Docket Item # 6
BAR CASE # 2008-0140

BAR Meeting
October 1, 2008

ISSUE: Addition and alterations
APPLICANT: Robert Bentley Adams & Associates
LOCATION: 701 South Royal Street
ZONE: RM/Residential

Figure 2. West elevation proposed for demolition/encapsulation.

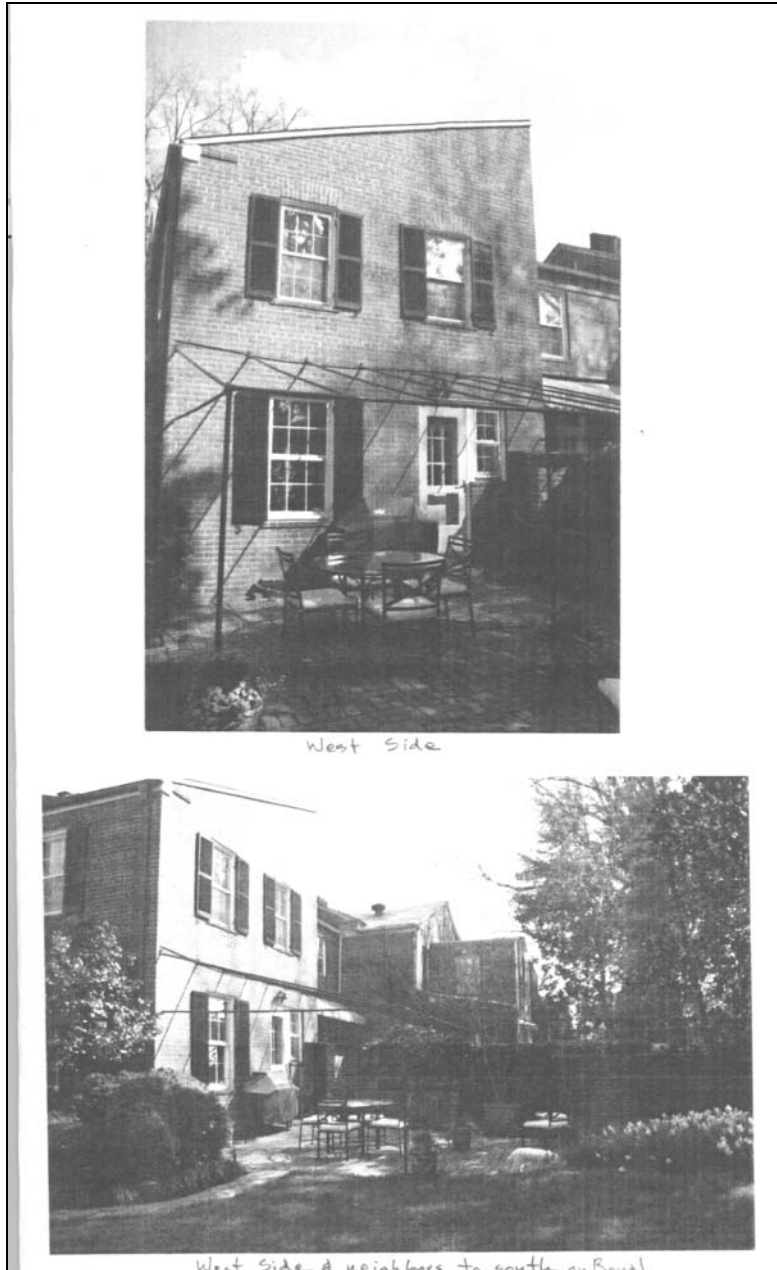
The east elevation will be demolished/encapsulated by the addition.

Figure 4. Existing entrance portico.

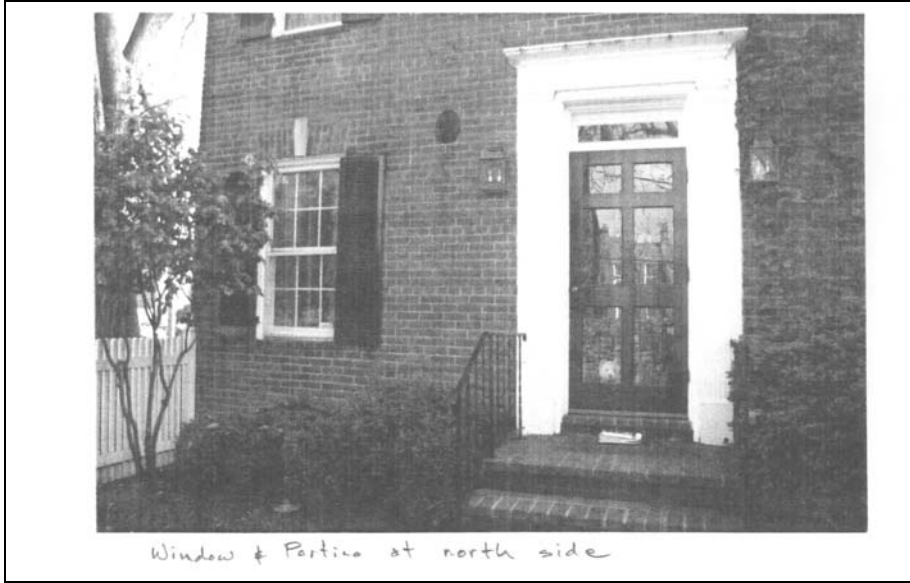
Staff finds that the proposed alterations to the existing townhouse are appropriate and consistent with the *Design Guidelines*. Although the first story window alterations will require the removal of some brick to accommodate the lower sill, Staff finds the proposed window type appropriate and consistent with similar properties in Yates Garden. Staff finds the repair and retention of existing windows and shutters to be appropriate. The new portico will be in keeping with the existing architectural style. Staff notes that the existing transom should be retained and repaired.

2. That the applicant retain the existing transom at the entrance.
3. That the applicant relocate the existing and the proposed A/C units from the front yard to the rear yard.

Figure 5. Proposed north elevation.

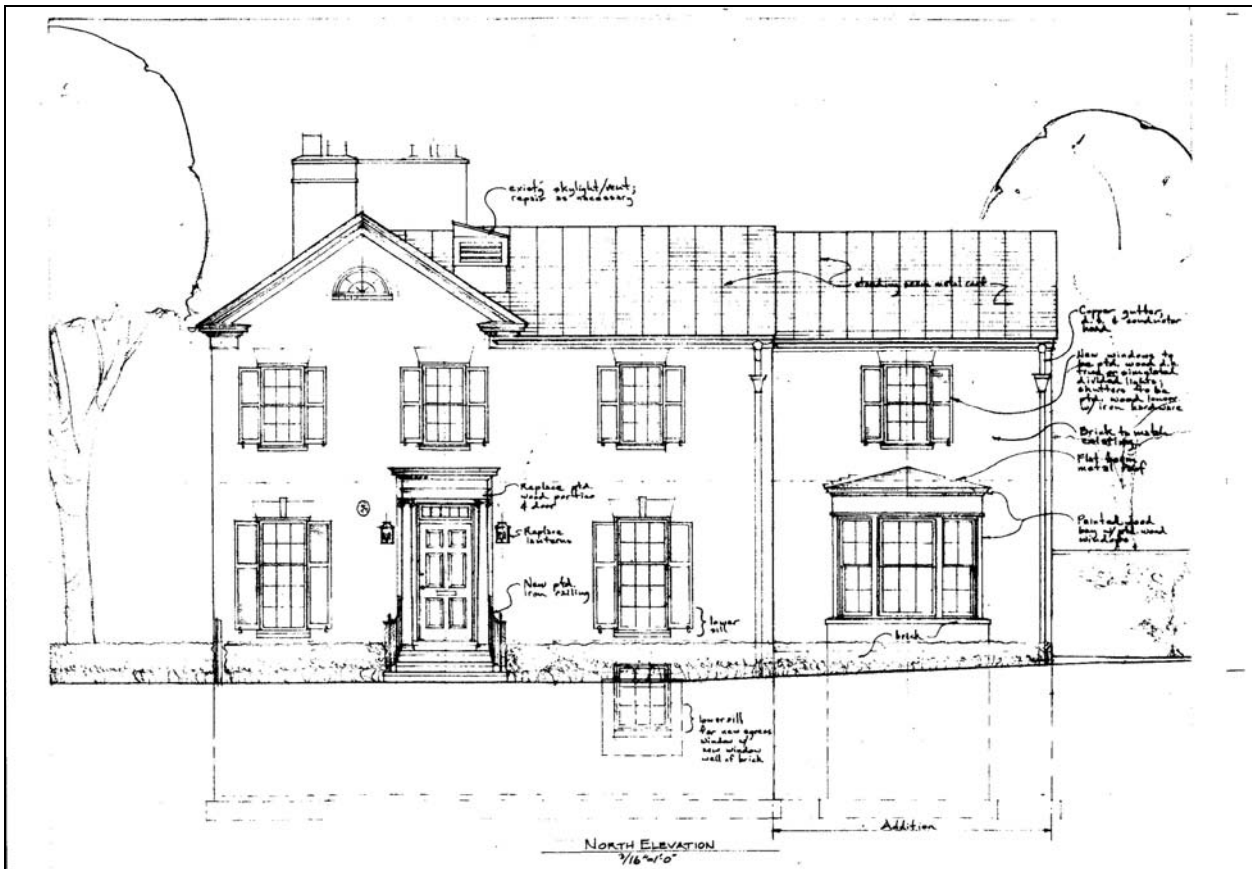
On the north elevation the applicant proposes to replace the existing Greek Revival portico and door. The existing portico with fluted pilasters will be replaced with a portico with Doric columns. The new door will be a six-panel wood door. A new painted metal hand rail will be

installed on the front steps. The existing lanterns at the entrance will be replaced. On the east and north elevations, the applicant proposes to remove a portion of the masonry wall to lower the sills of the first floor windows and then install six-over-nine double-hung wood windows with operable wood shutters. An existing basement window on the north elevation will be enlarged to accommodate a new egress window.

4. That the applicant work with Staff for final approval of design details, including the proposed lanterns, on the north and west elevations.
5. The statements in archaeology conditions below shall appear in the General Notes of all site plans and on all site plan sheets that involve demolition or ground disturbance (including Basement/Foundation Plans, Demolition, Erosion and Sediment Control, Grading, Landscaping, Utilities, and Sheeting and Shoring) so that on-site contractors are aware of the requirements:

Figure 7. Proposed west elevation.

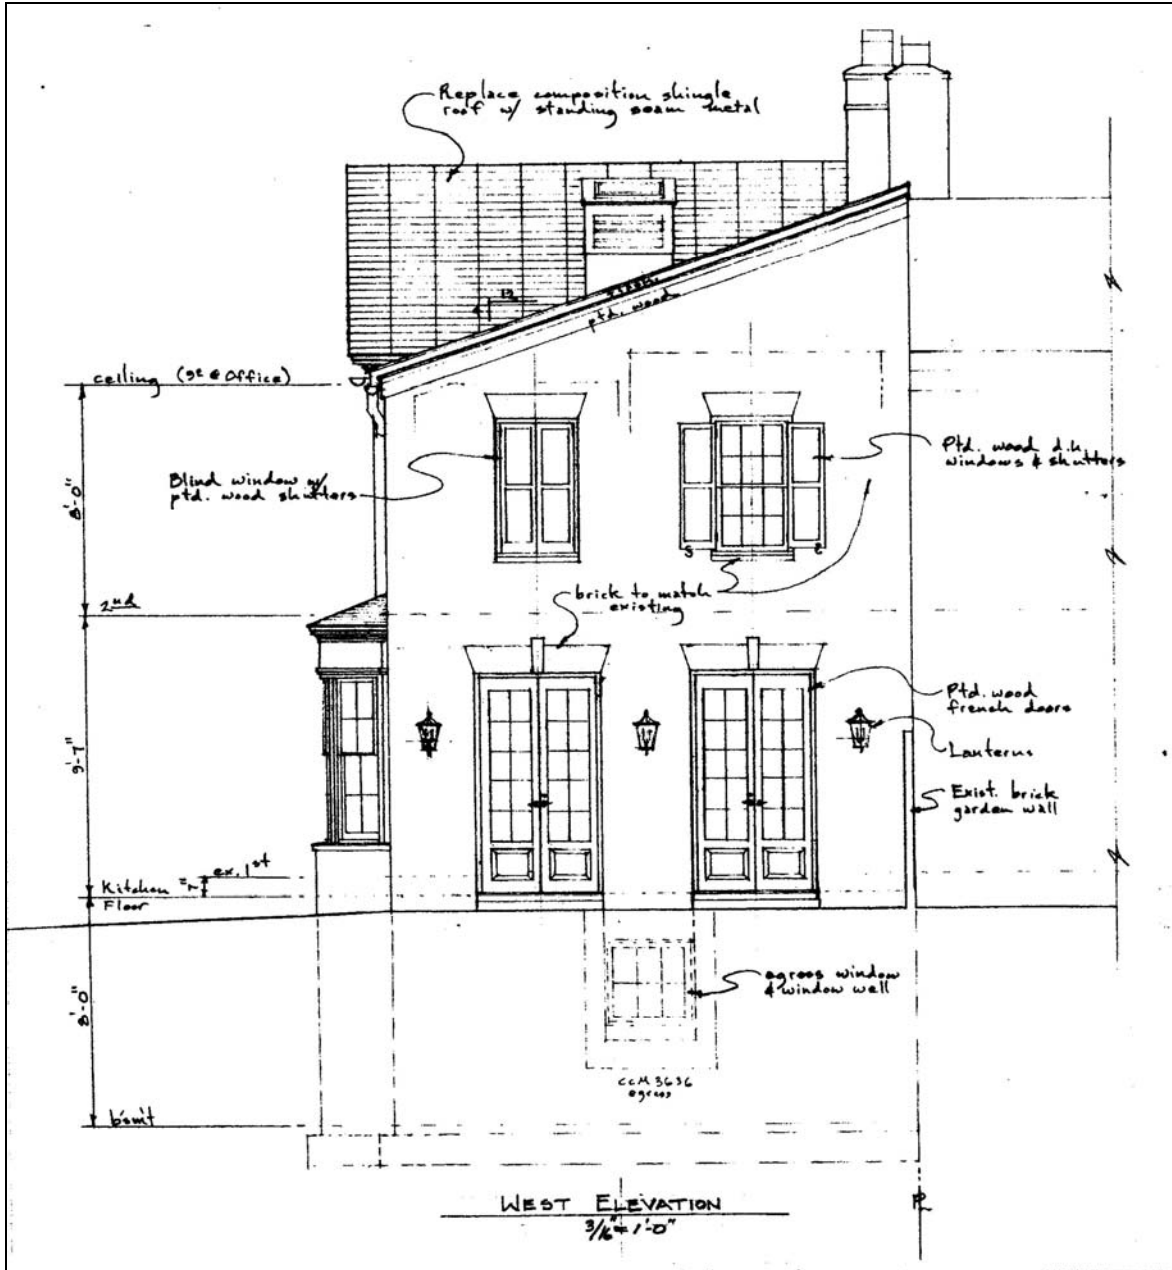
The west elevation will be two bays and have a flounder form, a continuation of the flounder form on a portion of the existing house. The basement level, completely below grade, will have a window well and egress window. On the first floor will be a pair of matching multi-light French doors. The second story will have a blind window with painted wood shutters on the north side and a six-over-six double-hung wood window on the south side.

1. That the proposed windows and French doors on the addition be single-glazed, true divided light wood windows to match the existing windows, and that Staff make final approval on the window specifications.
